STATE OF DELAWARE
DEPARTMENT OF TRANSPORTATION
800 BAY ROAD
P.O. BOX 778
DOVER, DELAWARE 19903

February 17, 2009

DeIDOT Contract Number: 95-090-01; Federal Aid Project Number: IM-N056(27)
I-95 Delaware Turnpike Improvements Project
I-95/SR 1 Interchange/I-95 Turnpike Mainline
Turnpike Mainline from SR 1 to SR 141; I-95/SR 1 Interchange; I-95 Northbound
Widening Extension
New Castle County, Delaware
Environmental Reevaluation [*Change in interchange design*]

The current reevaluation details modifications in the design of the I-95/SR 1 interchange portion of the project. The design changes are being incorporated into the project to provide additional traffic operational and safety improvements within the interchange. An environmental evaluation of the currently proposed design has been completed, and the changes would increase the impacts to wetlands by an additional 0.26 acres. Mitigation for this additional impact will be accommodated within the Cathcart wetland mitigation site (identified as Site 7 in the

Figure A.5: I-95 Widening “Modified Design” Visual Screen Fence Envelope Sketch

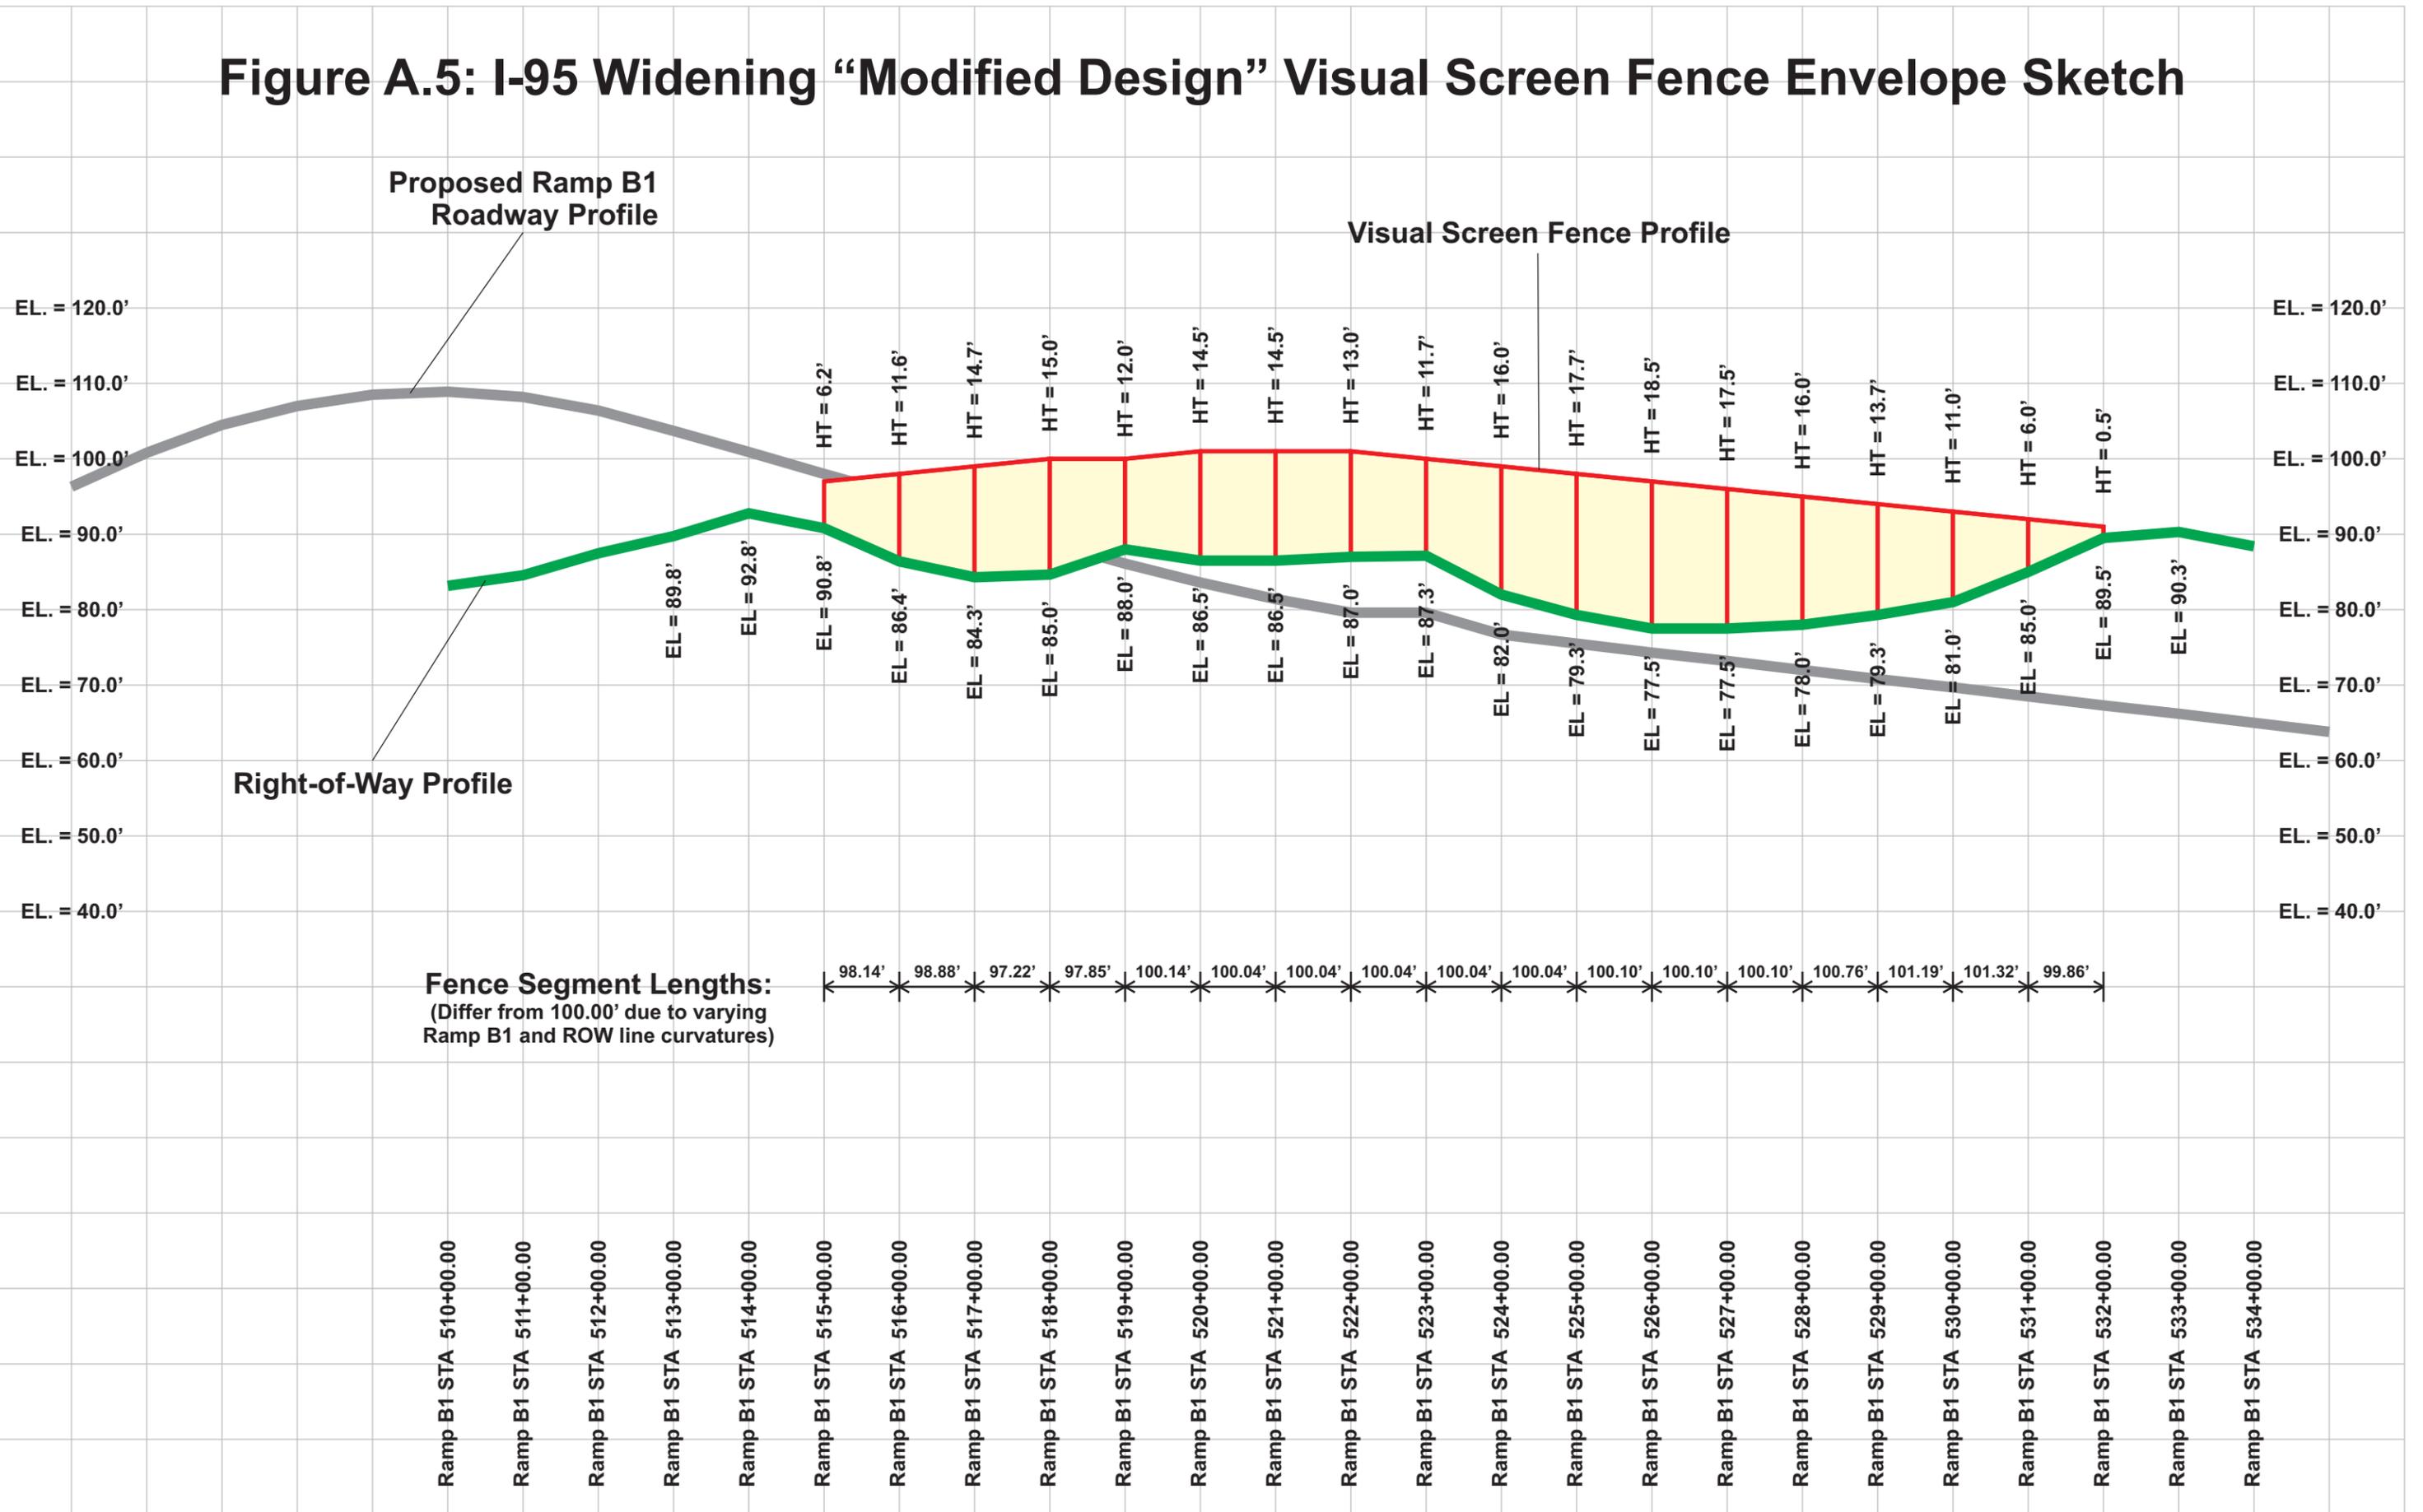
Although noise mitigation is not recommended in conjunction with the modified design, if constituted of materials certified and rated to reduce sound transmission, a visual screening fence constructed along the right-of-way limits would provide reductions below Build condition traffic noise levels to residences within the study area. Based on the predicted noise level reductions of an FHWA-approved solid noise wall, such a fence would provide at least five decibels of traffic noise level reduction to all design year 2030 Build condition traffic noise impacts, as shown in **Table A.3**, on page 9, if it were approximately 1,700 feet long and approximately 23,000 square feet, as shown in **Figure A.5** on page 15, and as described in **Table A.4**, on page 10.
